SECTION 00942 – Change Order Form

No. 1DATE OF ISSUANCE: May 10, 2024EFFECTIVE DATE: May 10, 2024

OWNER: Indian River County
 CONTRACTOR: Close Construction Services
 Project: Kiwanis Hobart Park New Restroom
 OWNER'S Bid No. 2023047

RISER DIAGRAM

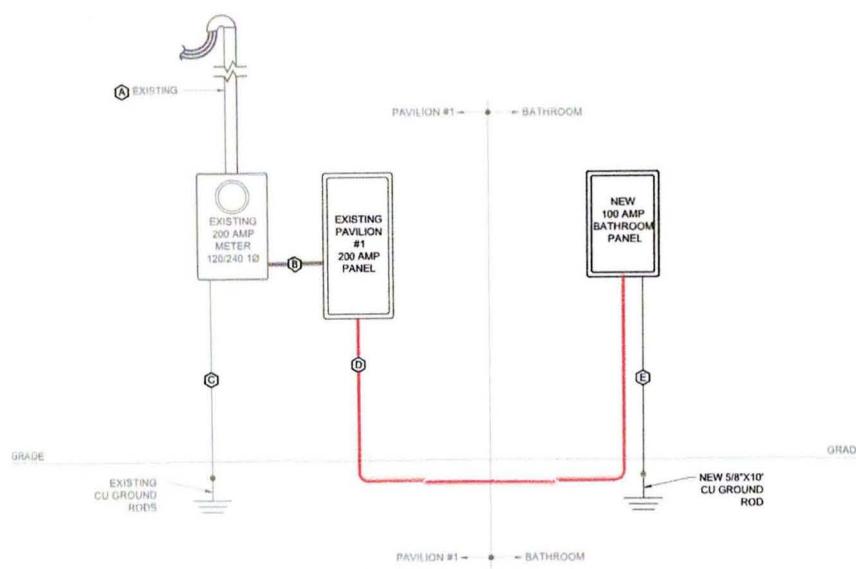
Per the “proposed riser changes” indicated on Page E-1, we are pleased to offer the following proposal to extend the electrical conduit and wire an additional 30’ to an existing panel and pull the power from the existing meter and panel, including necessary saw cutting and patching:

The building inspector has asked that the Page E-1 be amended, signed and sealed so that we may submit it to the building department to update the permit and permitted plans.

- INSTALL (1) 100 AMP SUB PANEL AT NEW BATHROOM STRUCTURE.
- FEED NEW BATHROOM PANEL UNDERGROUND FROM EXISTING 200 AMP PANEL AT PAVILION #1.
